OC Transpo Transitway Station Design Safety Study

Independent Safety Study

Final Safety Study

INDEPENDENT ROAD SAFETY STUDY

Issue 26: Conspicuity of tactile surface

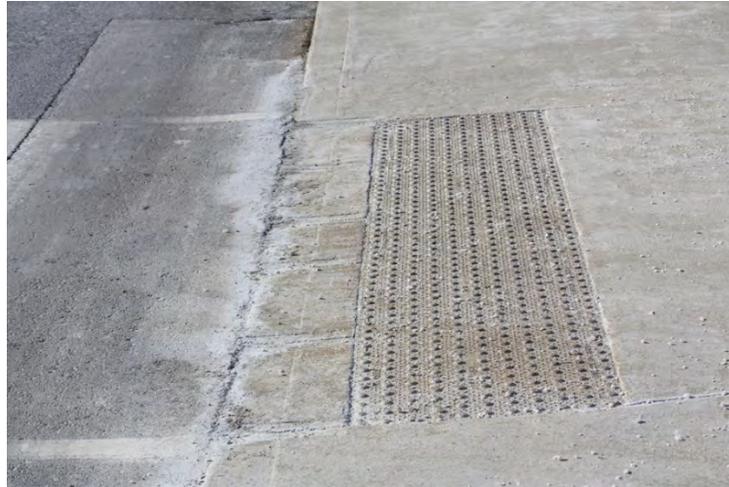
The tactile surface for the entrance to the crosswalk is not conspicuous in comparison to the concrete sidewalk. Most people with a visual impairment have some sensory abilities but may not be able to discern between objects unless they have high contrast. Many people start to suffer vision loss after the age of 65 years. For these people, there may be a limited perception of the path ahead and obstacles. Such people would need to rely entirely on non-visual indicators to find this textured plate.

Install Accessibility for Ontarian with Disability Act (AODA) approved high tonal tactile surface. Although the colour of the tactile surface is not specified in AODA, the common high contrast colour standard for most jurisdictions in North America is yellow.
